Application No.	Applicant(s)	•
Notice of Allowability	10/765,074	SCORER, MICHAE	L
	Examiner	Art Unit	
	Benny Lee	2817	
The MAILING DATE of this communication appear All claims being allowable, PROSECUTION ON THE MERITS IS herewith (or previously mailed), a Notice of Allowance (PTOL-85) NOTICE OF ALLOWABILITY IS NOT A GRANT OF PATENT RI	(OR REMAINS) CLOSED in this app or other appropriate communication GHTS. This application is subject to	olication. If not include will be mailed in due	ed course. THIS

EXAMINER'S AMENDMENT

Application/Control Number: 10/765,074

Fig.8.

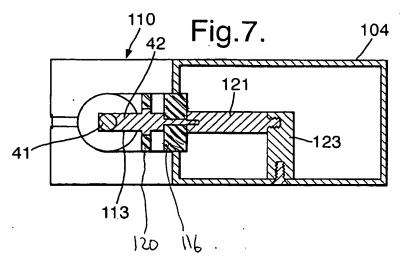
upon by applicant: In Fig. 3, the dielectric beads (16, 20) should be cross-hatched as a dielectric

material, in a manner similar to that depicted by Fig. 2; In Figs. 7, 8, the dielectric beads (116,

120) should be cross-hatched as a dielectric material, in a manner similar to that depicted by Fig.
